Memorandum

Attention: Charlotte Scotchbrook
 Company: Selwyn District Council
 Date: 10th May 2022
 From: Claire Kelly/Boffa Miskell on behalf of KeaX
 Message Ref: Response to request for further information
 Project No: BM219727/RC225180

Please find below KeaX's response to your request for further information dated 28th April 2022.

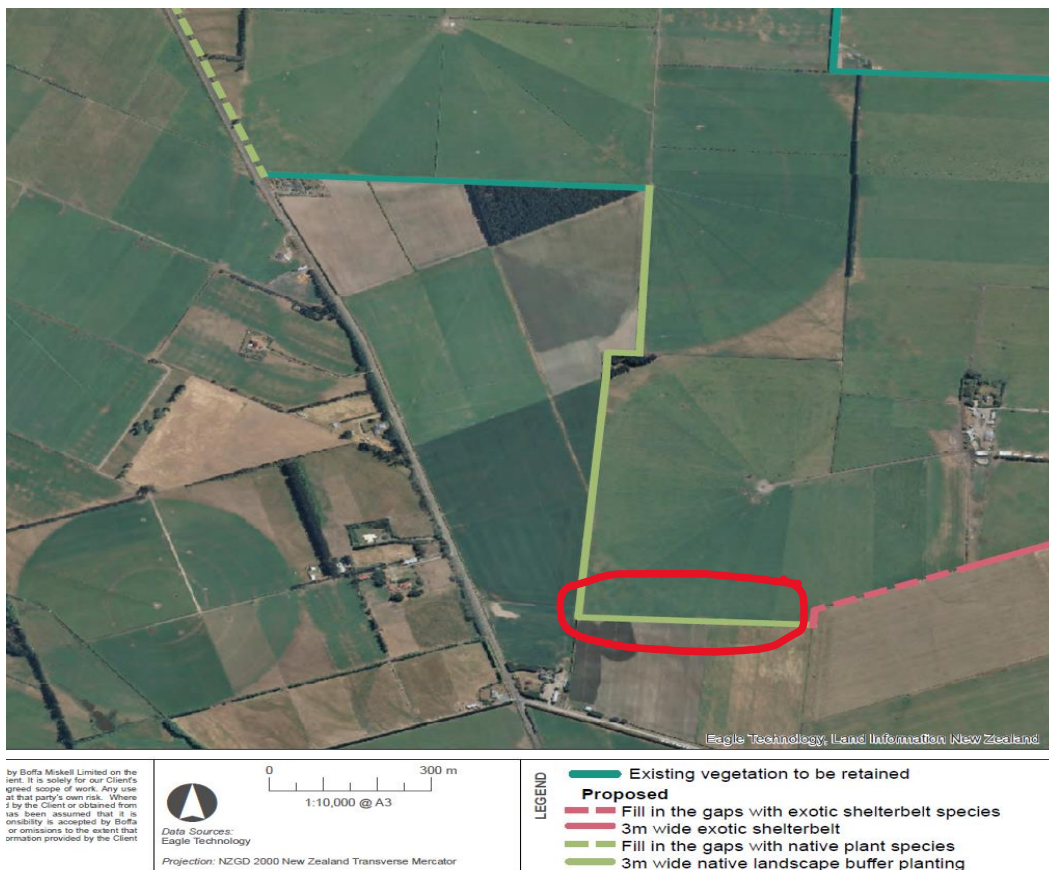
- b. *Page 15 of the Landscape and Visual Assessment makes reference to that area of the site which retreats inland from Branch Drain Road as being filled with exotic shelterbelt species and planted in double staggered rows to provide screening for Stage 2. Please confirm what screening/area shown on Figure 3 of the landscape assessment is being referred to as the legend in Figure 3 appears to suggest native planting is proposed, if I have the correct area.*

The AEE states that 'the existing Site boundary shelterbelts and landscaping will be retained, except for the shared boundary with 180 Grahams Road. Along this boundary, the existing exotic shelterbelt plantings will be removed and replaced with a 3m wide native buffer planting.' This is correct and Figure 3 in the LVEA is correct – the area to be replanted is highlight below.
